## SIB 61 12 20

### TRUNK LOCK SWITCH INSIDE THE GLOVE COMPARTMENT IS MISSING

2020-05-18

This Service Information Bulletin (Revision #) replaces SI B61 12 20 **dated April 2020**.

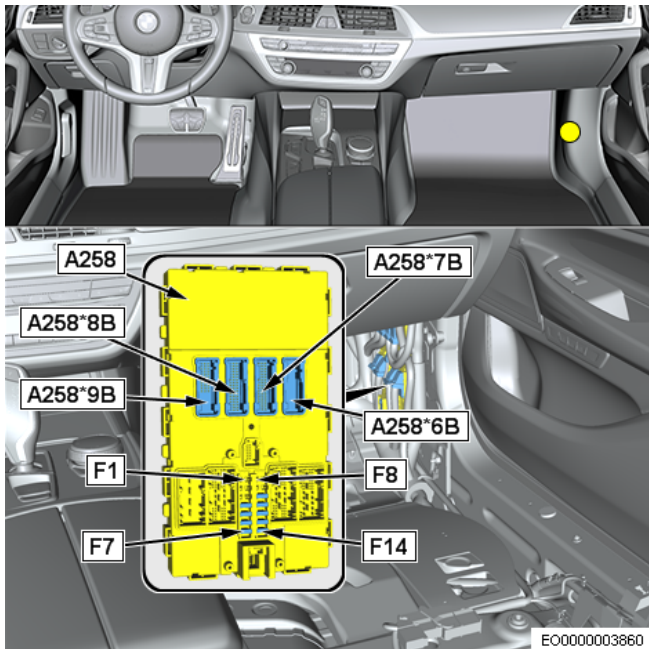
The trunk lock switch ("hotel"/valet switch) is missing in the glove compartment. This switch decouples the trunklid from the central locking system so that the trunklid cannot be opened.

Refer to the procedure section to retrofit the trunk lock switch.

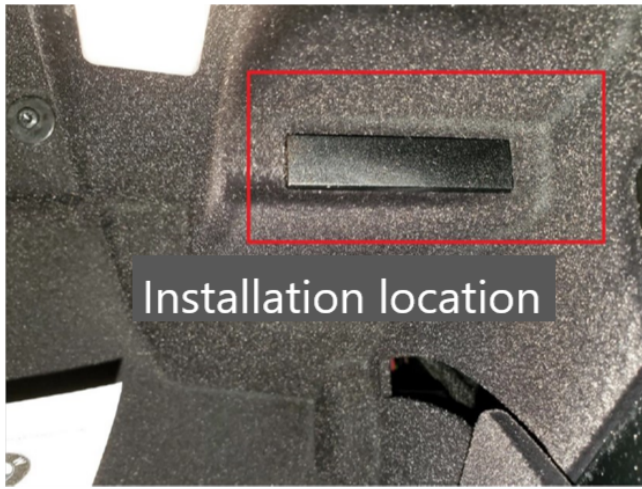
1. Disconnect all negative battery leads and access the BDC connector A258\*7B.

Refer to repair instructions 61 35 278 (**no removal of the BDC is necessary**).

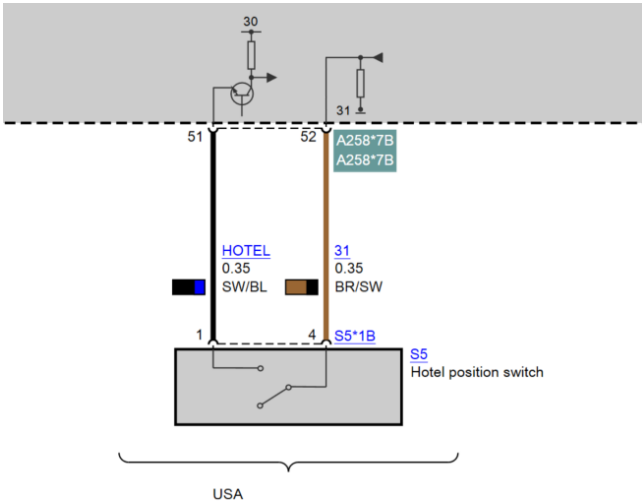
2. Crimp the MQS bushing contacts onto the ends of both extension wires (900 mm long / 18 AWG diameter) and connect them to the hotel position switch using the universal socket housing.
